# DS PSE SD MODIFICATION

Chad Jones

Cisco Systems, Inc.

# Primary Alternative dual-signature semi-independent PSE state diagram

# Modifications continued

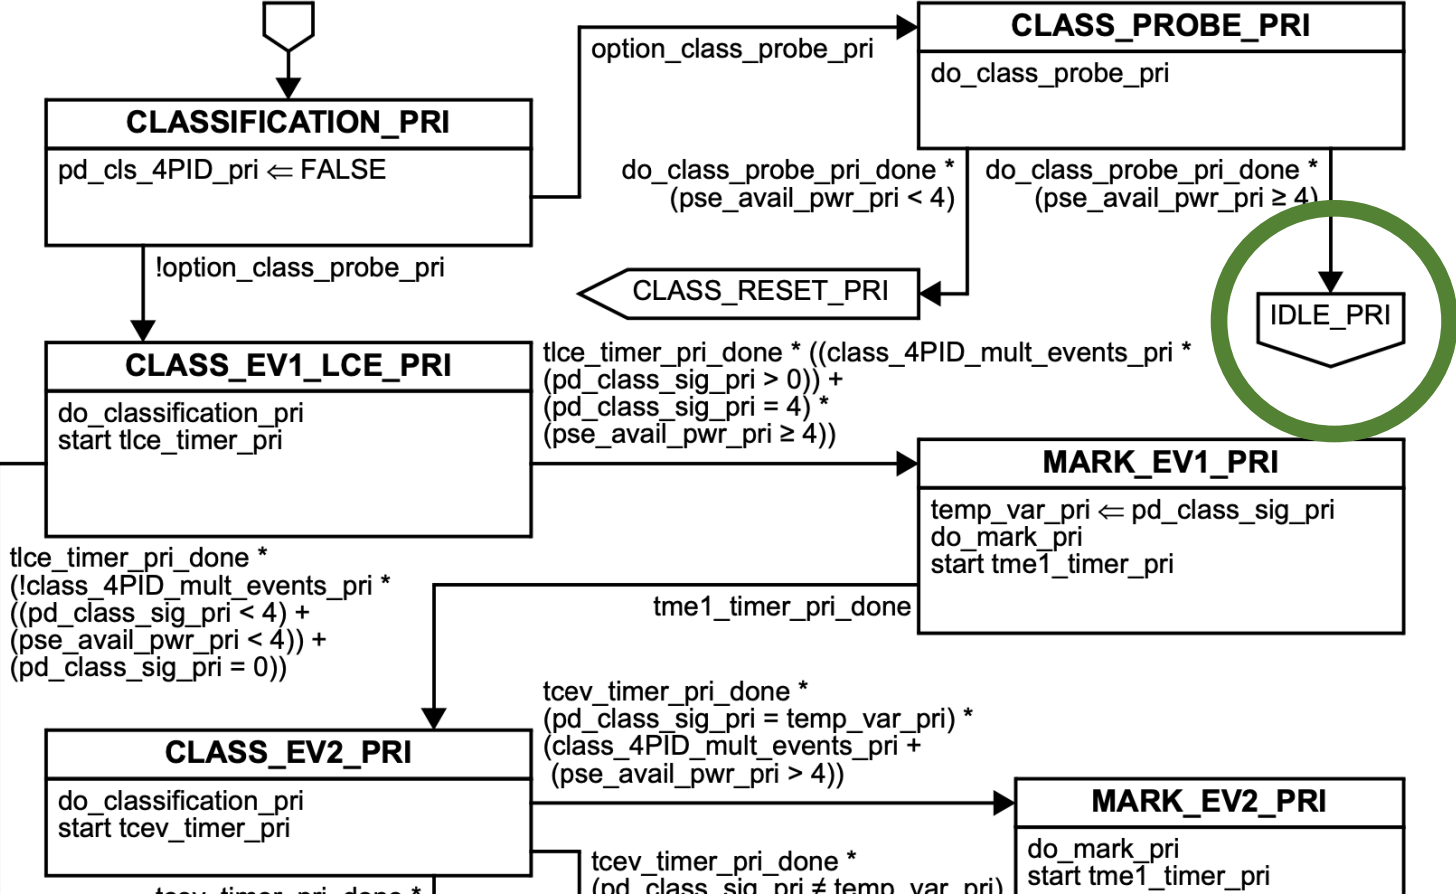
pse\_enable  
 A variable that selects PSE operation. This variable may be set by the PSE at any time. Values:  
 disable: All PSE functions disabled (behavior is as if there was no PSE functionality).  
 enable: Normal PSE operation.
